# PERMIT

## SEWAGE DISPOSAL SYSTEM

#### HOWARD COUNTY HEALTH DEPARTMENT

A REPAIR

P 58127

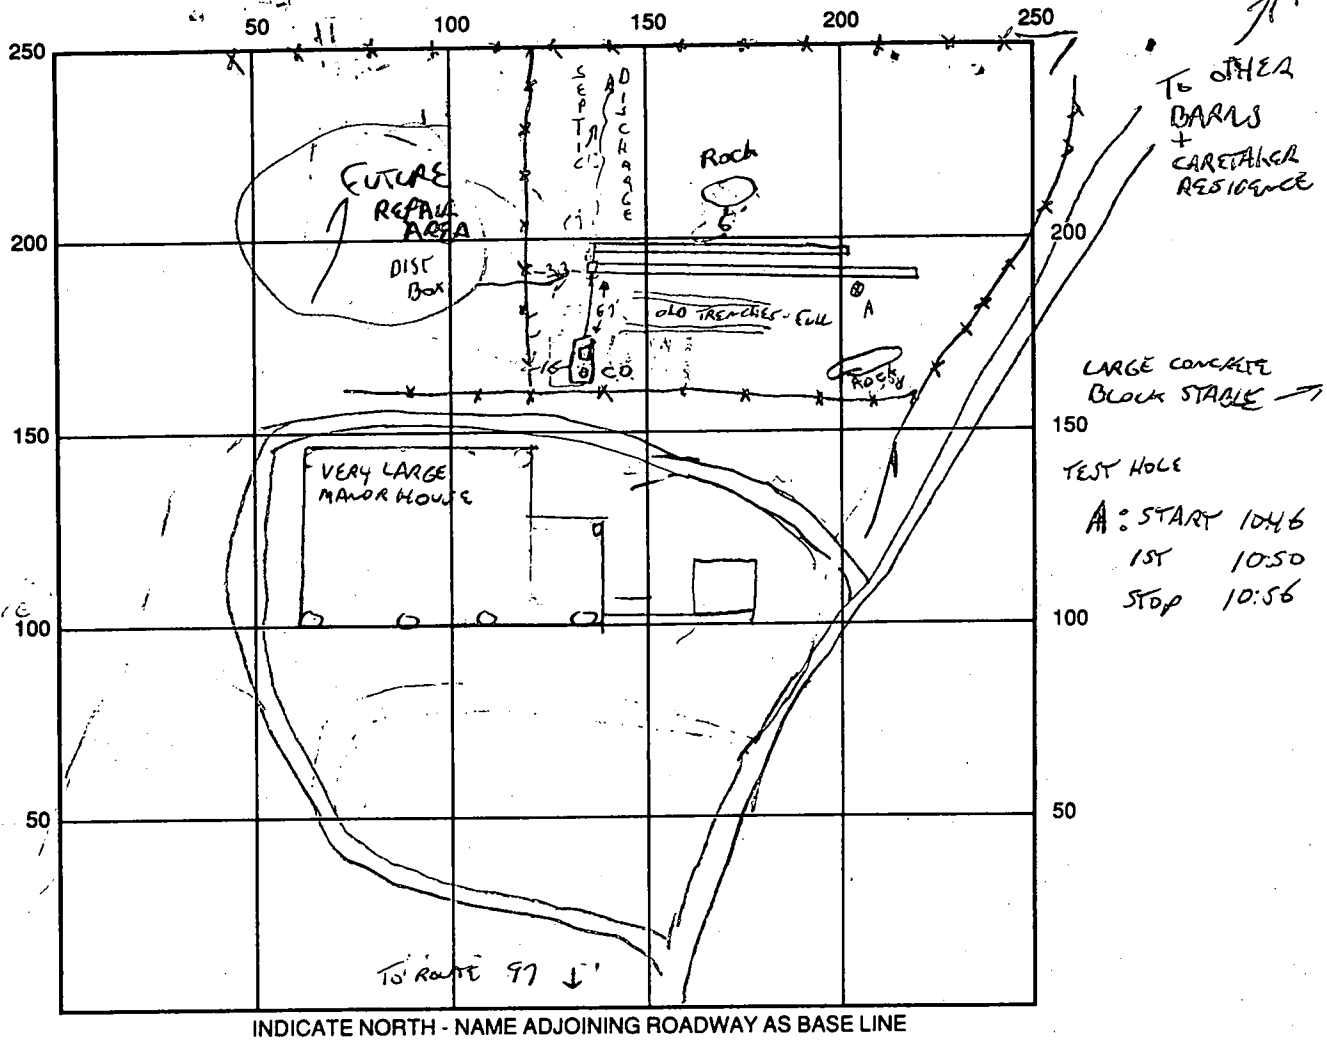
REPAIR - PURPOSE - SEPTIC SYSTEM HAS FAILED.

Call for inspection when ground is opened so sanitarian can recommend repair.  
05/01/97

1. TRENCH 4' WIDE, WITH 2 BOXES 4' OK TO REUSE STONE

TO 1.5' MAXIMUM BOXES DEPTH 4.5' TO ALLOW FOR CONTOUR

VARIATIONS IF NEEDED

SEPARATION BETWEEN TRENCHES MAY BE REDUCED TO 6" IF NEEDED  
DUE TO ROCK

REMARKS: 5/8/97 TRENCHES OK TO COVER, OLD DIST BOX  
REMOVED, OLD TRENCHES CUT OFF.

44466

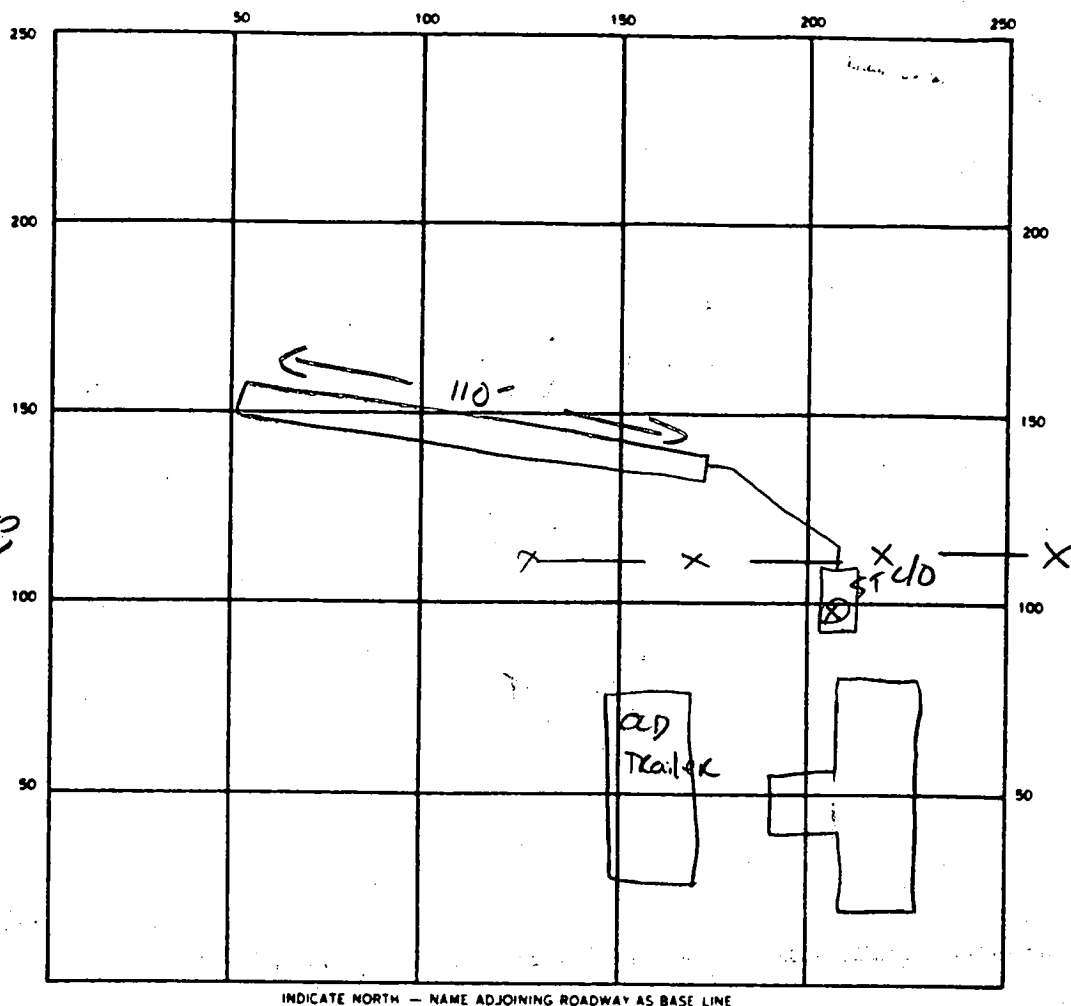
REPAIR - CALL FOR INSPECTION WHEN GROUND IS OPENED UP SO SANITARIAN CAN RECOMMEND REPAIR.

INLET 3' BOTTOM 8' 5" STONE - 100 FEET OF TRENCH.

OK TO STONE TRENCH AS DUG.

REMARKS 6/5/89 - EXISTING TRENCH SYST INTERCEPTED. WAS N 3' below grade w/ only  
STONE AND old ORANGE/CAST IRON PIPE; Replace w/ 100' of TRENCH w/ 5'  
STONE. Soils GOOD. Sabel
